**ISSUE:** Permit to Demolish/Capsulate (partial) and Certificate of Appropriateness for alterations

**LOCATION:** Old and Historic Alexandria District  
115 South Union Street

**STAFF RECOMMENDATION**

The applicant requests a Permit to Demolish/Capsulate (partial) and Certificate of Appropriateness to add two windows to the second level of the north, alley-facing, elevation of 115 South Union Street. This will require the demolition of 184 square feet of masonry, 92 square feet per window.

Figure 1: Existing and proposed with target area circled

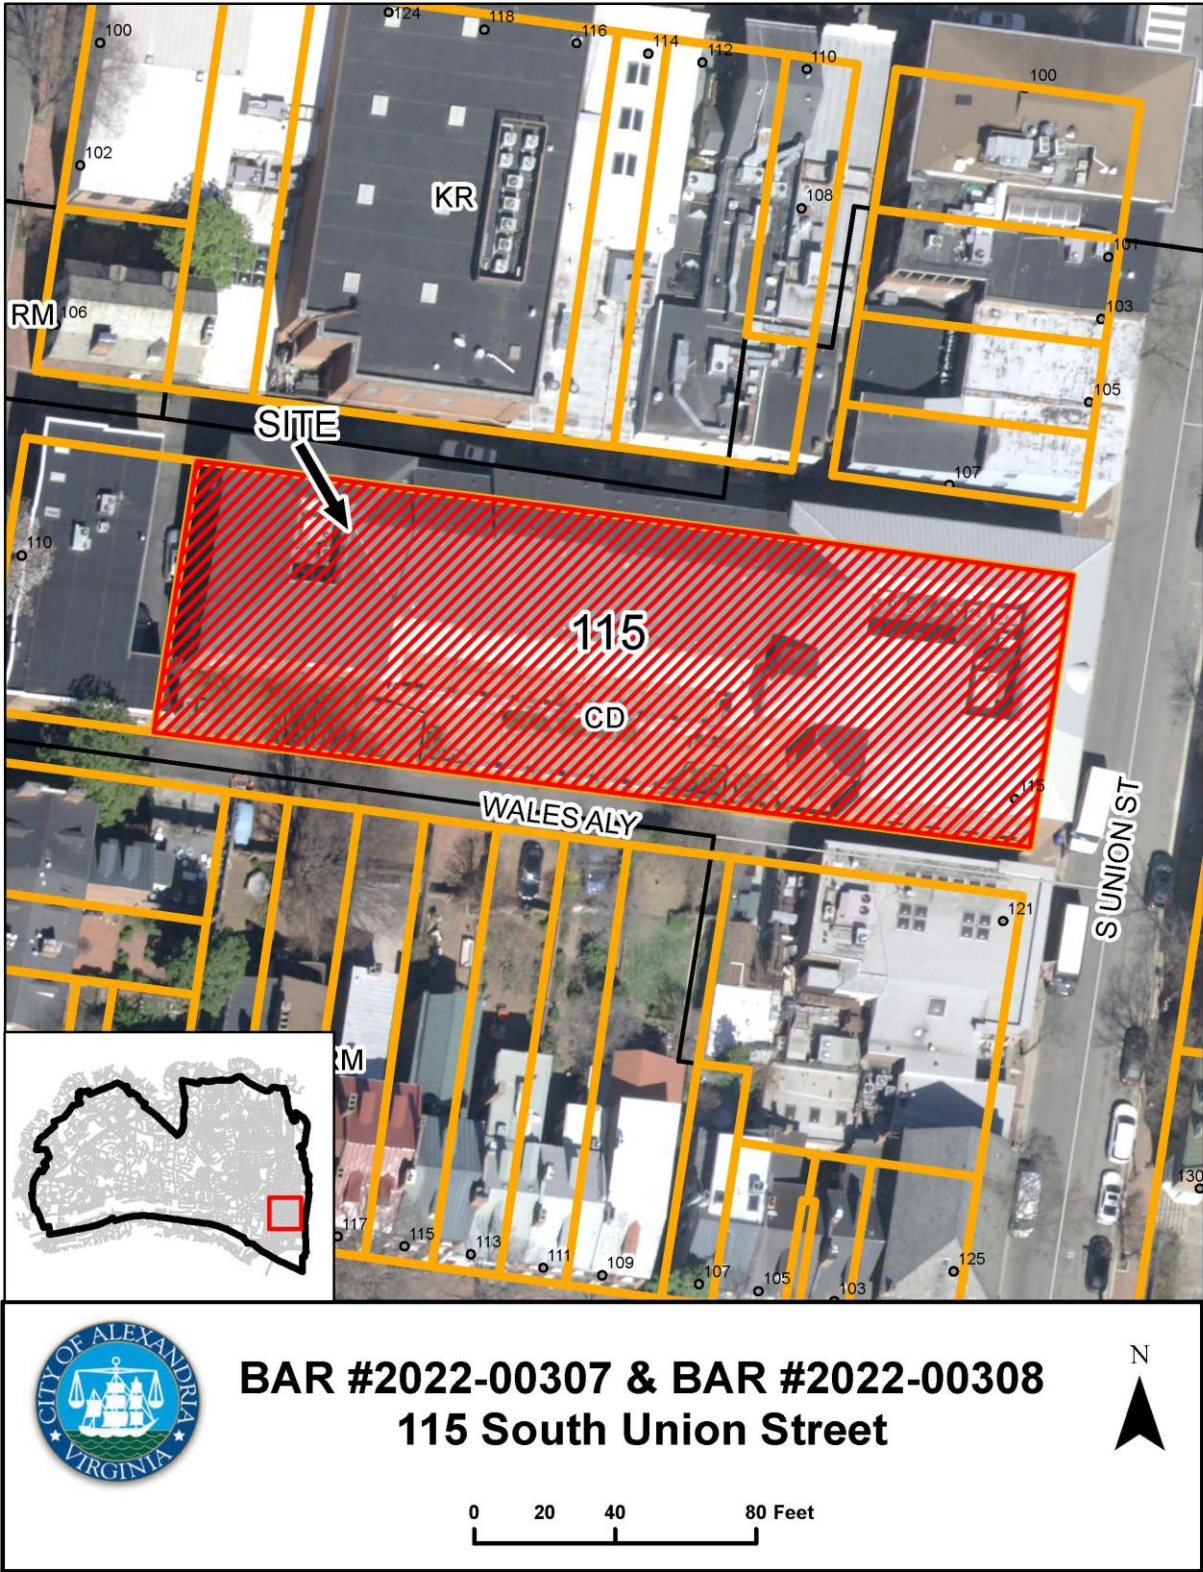
The *Design Guidelines* note that “Windows are a principal character defining feature of a building and serve both functional and aesthetic purposes.” As noted above, this is not an historic building so the primary concern of the Board should be whether these proposed windows are appropriate to the building and its surroundings. Figure 1, photographs taken from South Union Street, depicts the existing wall without windows and the proposed wall with windows. Staff finds that the addition of these windows greatly improve the appearance of this elevation, giving the blank wall a more welcoming and less austere look. The windows activate the elevation. The replication of the existing windows will provide a unified look to the overall building. The submitted specifications for the proposed windows indicate that the aluminum storefront system and the

Pilkington glazing comply with *Alexandria New and Replacement Window Performance Specifications in the Historic Districts*.

Staff therefore recommends approval of the project.
